# SMART SCALE ROUND 4

Madison County Board of Supervisor Meeting

## Route 230 & Route 687 (Pratts) Intersection Improvements

Shown is the original concept from the RKK Study

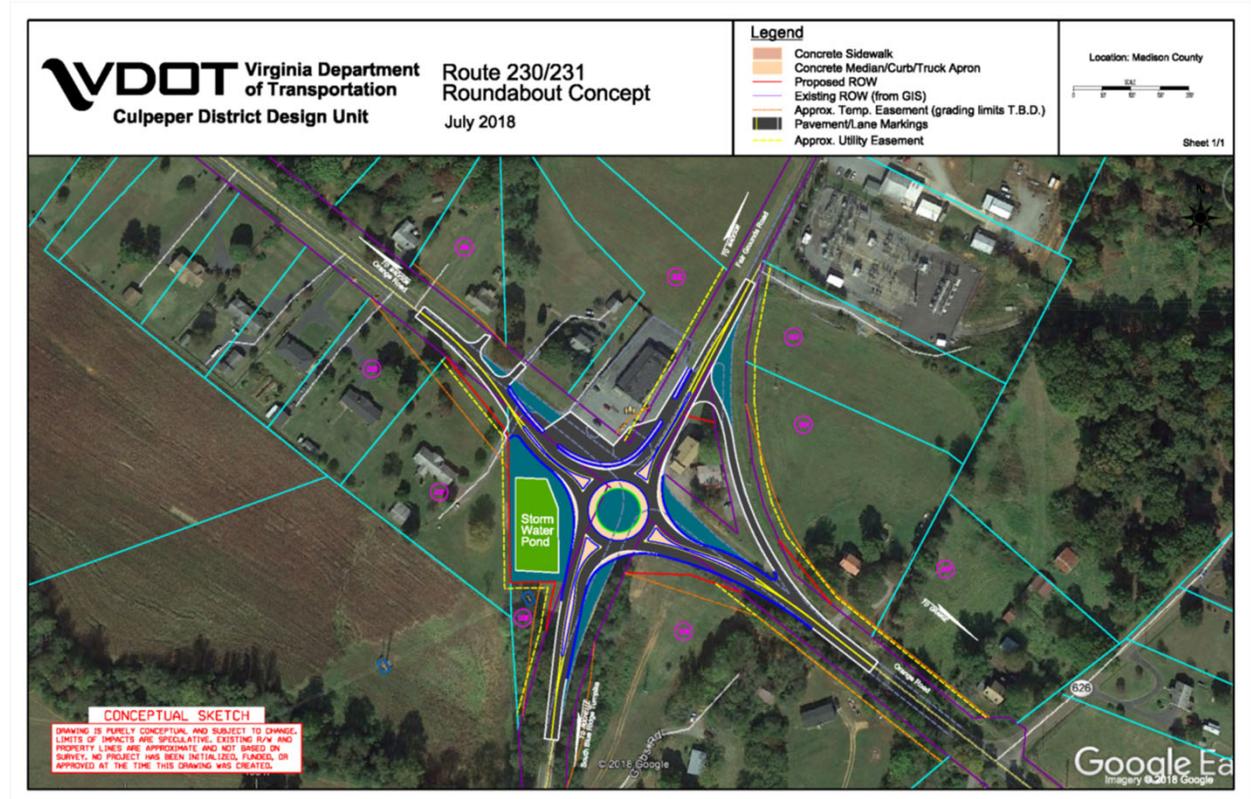
- Stormwater Management Facility was not shown;
- The geometry of the roundabout is not adequate for larger vehicle types;
- Approaches curves are not adequately developed to reduce speeds

Shown is the concept sketch developed by VDOT for the Round 3 Application

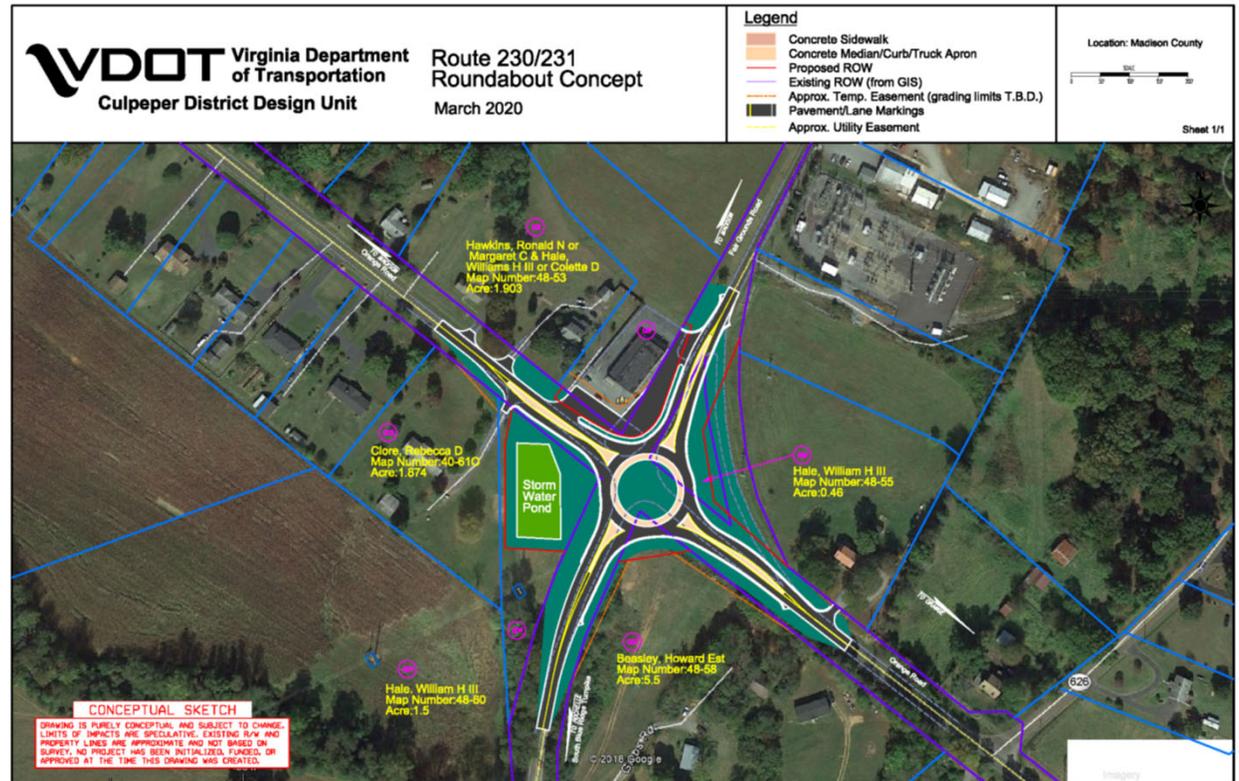
- 11 Parcel Impacted
- Requires outside truck aprons
- RW concerns with the William H Hale III Parcel due to unknown well & septic locations and access/parking restrictions.
